Origination Form
Proposed Revisions to a Standard Plans Index

Originator:	Frimmel, James	Index Number:	522-002
Date:	4/29/2025	Sheet Number(s):	1 & 7 of 7
E-mail:	james.frimmel@dot.state.fl.us	Index Title:	Detectable Warnings and Sidewalk Curb Ramps

Summary of the changes:

Sheet 1: Added RAILROAD CROSSING Notes 1 and 2 from Sheet 7 as GENERAL NOTE 5, to to provide clarity on the 4'-0" full-height separation requirement. Sheet 7: Deleted the 4 - PLACEMENT OF SIDEWALK CRUB RAMPS AT CURBED RETURNS details.

= CURB RAMP NOMENCLATURE

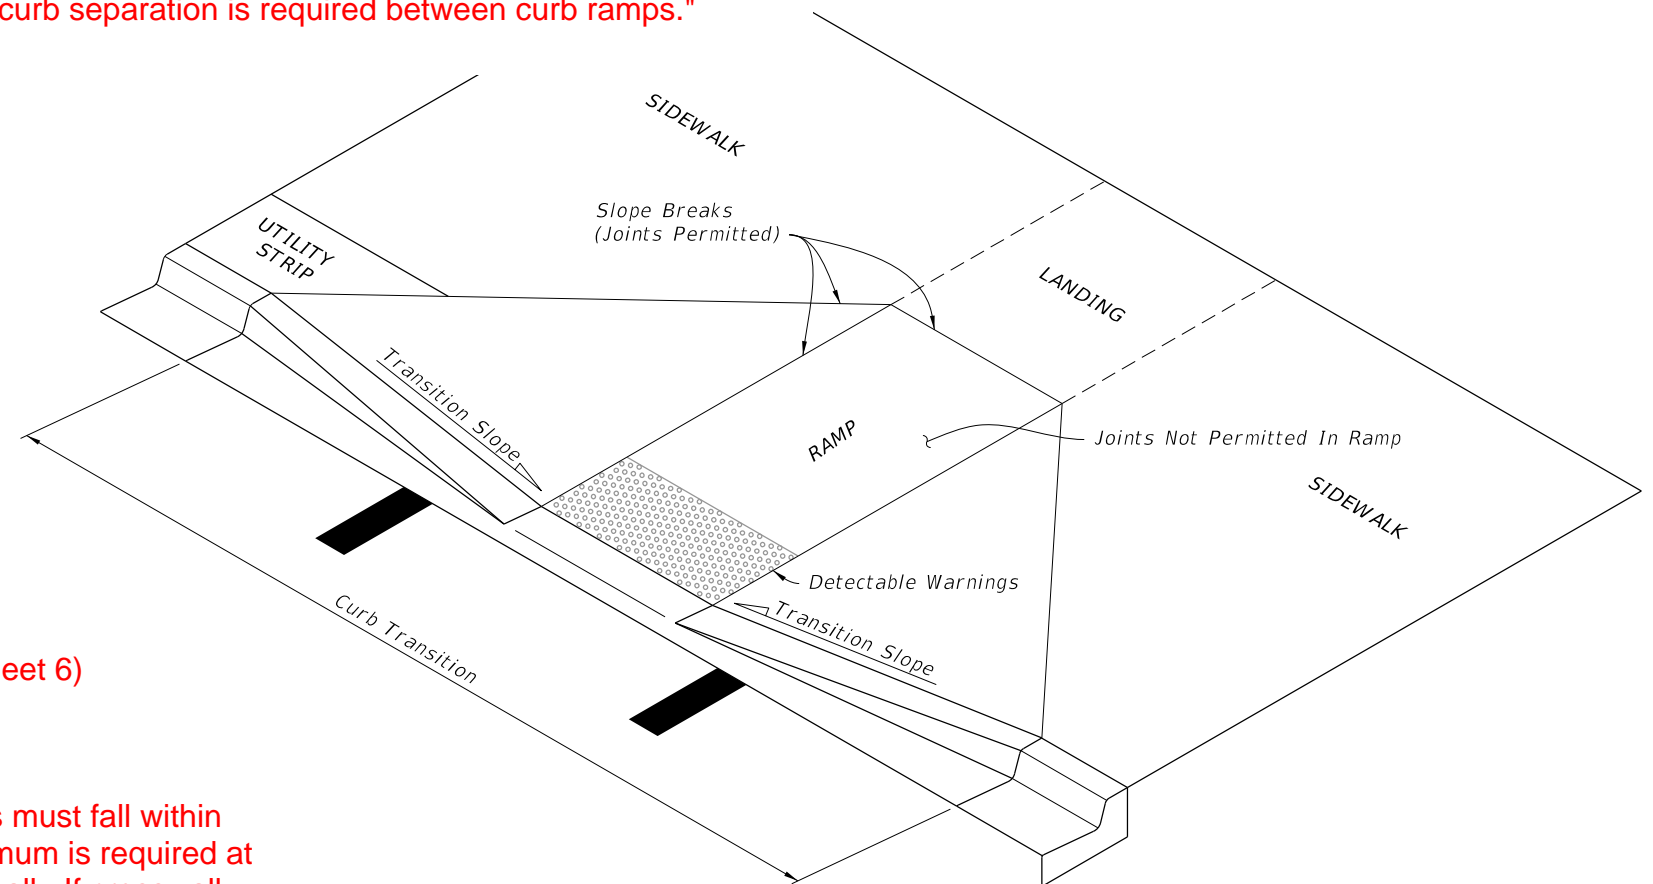
- ADDED New Note 2.D:
 "Where multiple ramps exist, a minimum 48" full-height
 curb separation is required between curb ramps."

5. Crosswalks

- A. Where crosswalk markings are used, ramps must fall within the crosswalk limits. A clear space of 48" minimum is required at the bottom of the ramp within a marked crosswalk. If crosswalk markings are not present, a clear space of 48" minimum is required at the bottom of the ramp outside of active travel lanes.

B. Crosswalk widths and configurations vary; must conform to Index 711-001.

RAILROAD CROSSING

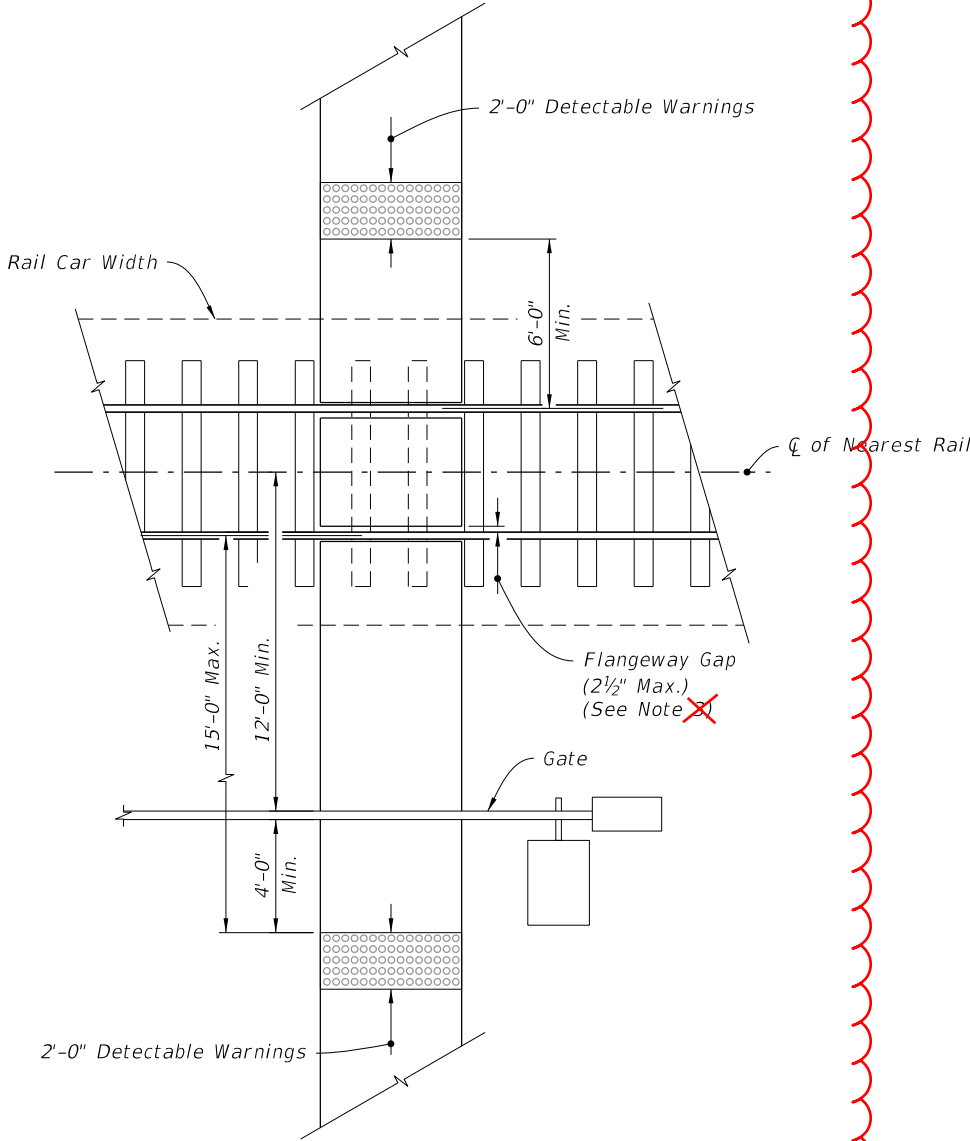
NOTES: **MOVED: Notes 1 and 2 to Sheet 1**

- ~~1. Where crosswalk markings are used, ramps must fall within the crosswalk limits. A clear space of 48" minimum is required at the bottom of the ramp within a marked crosswalk. If crosswalk markings are not present, a clear space of 48" minimum is required at the bottom of the ramp outside of active travel lanes.~~
- ~~2. Crosswalk widths and configurations vary; must conform to Index 711-001.~~
3. Flangeway Gap may be up to 3" for Freight-only Railways.

PLACEMENT OF SIDEWALK CURB RAMPS AT CURBED RETURNS (TYP.)

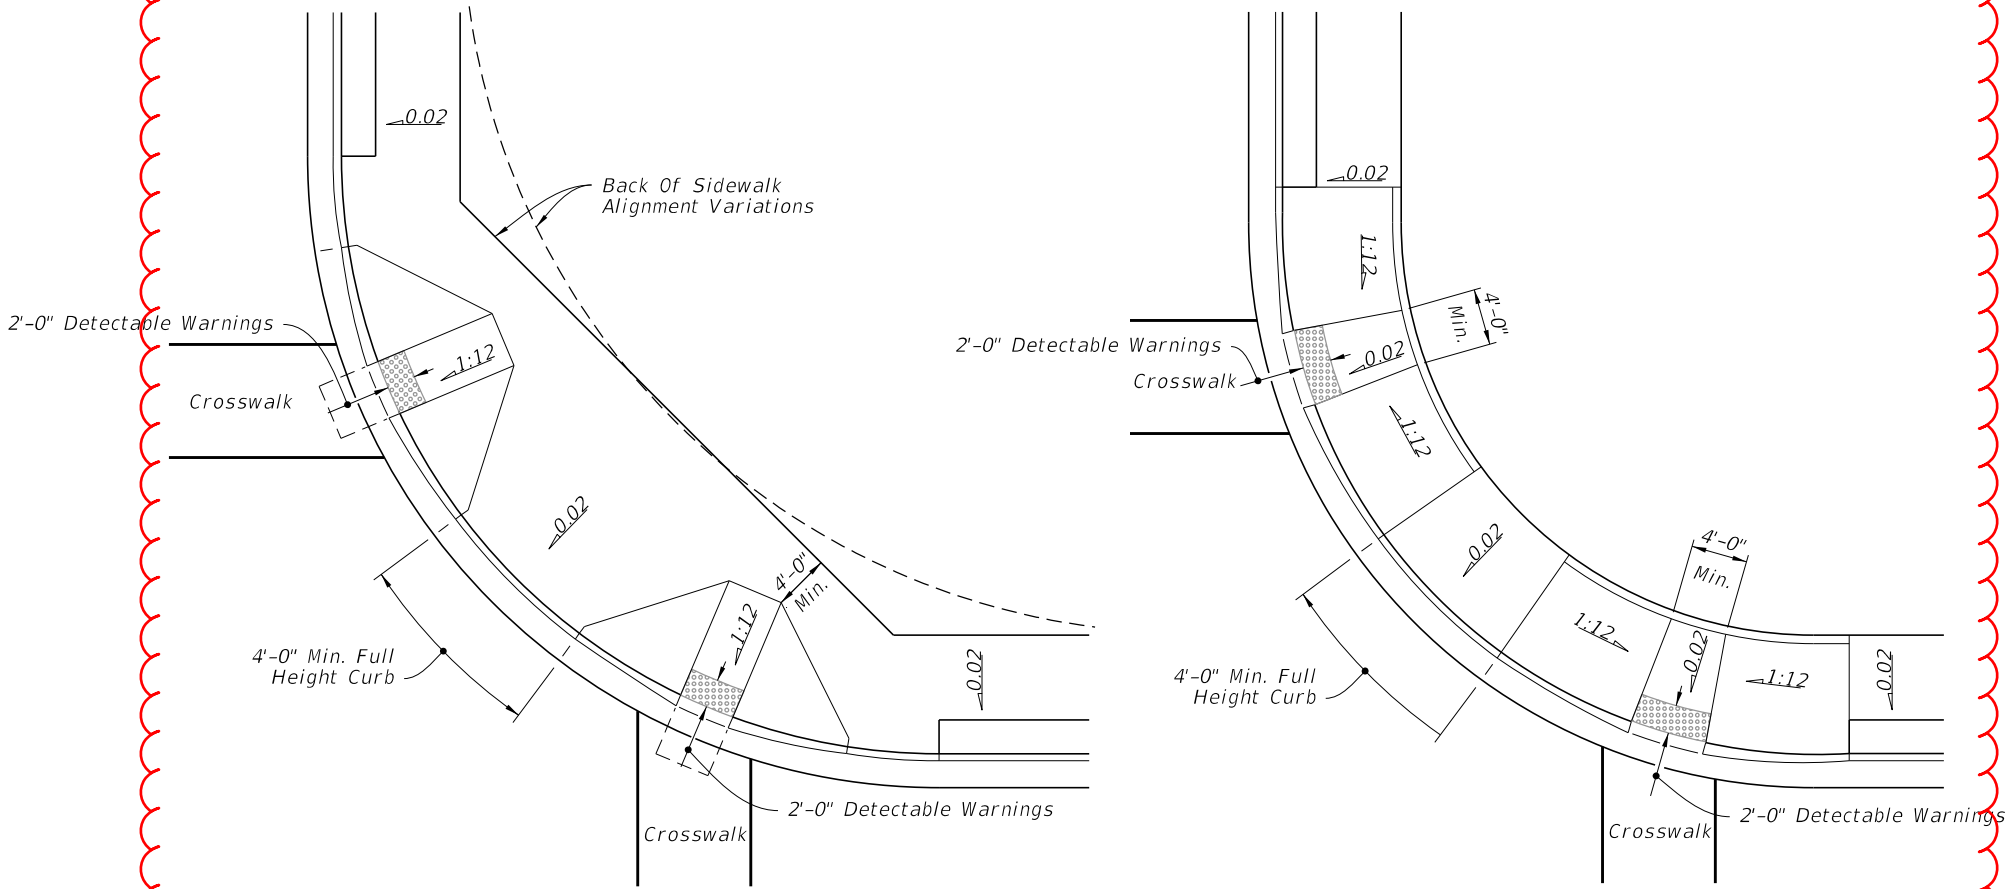
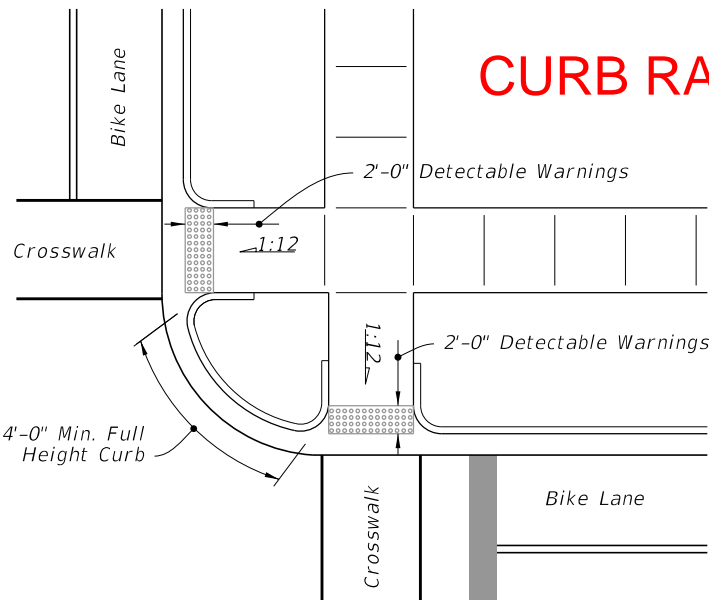
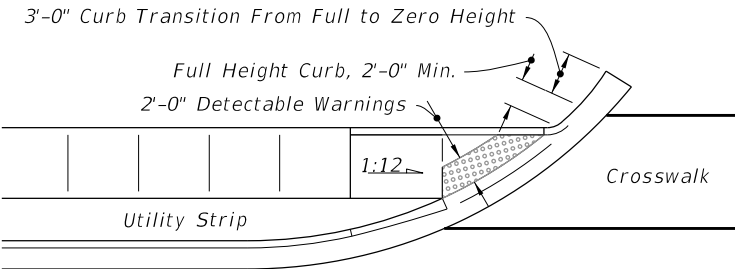
**DELETED:
CURB RAMPS AT CURBED RETURNS**

RAILROAD CROSSING

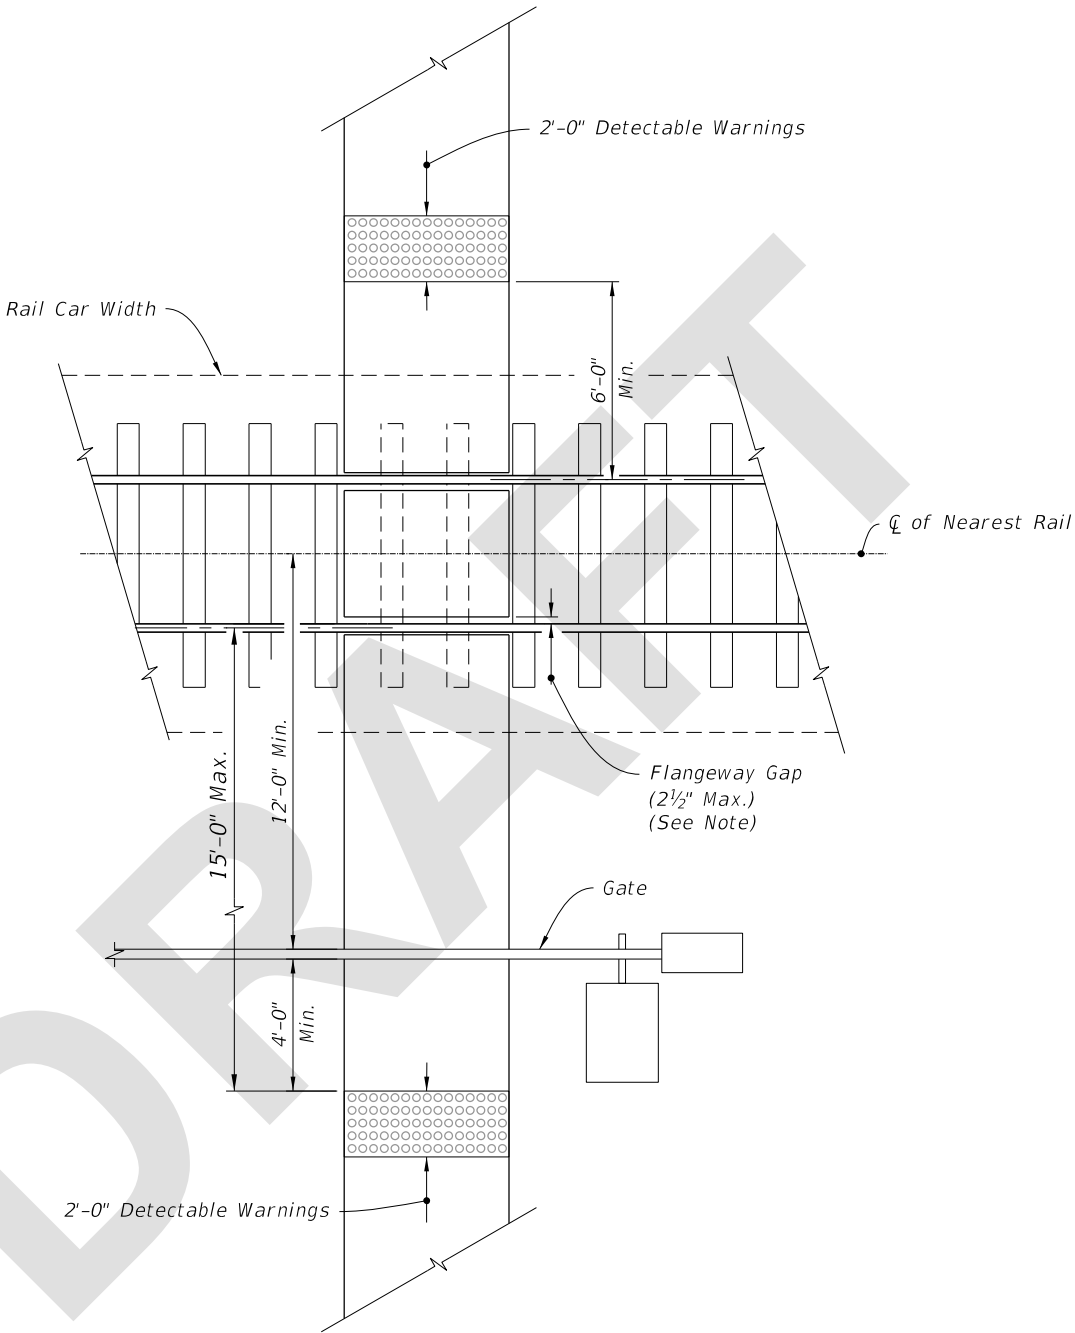
NOTE:

Flangeway Gap may be up to 3" for Freight-only Railways.
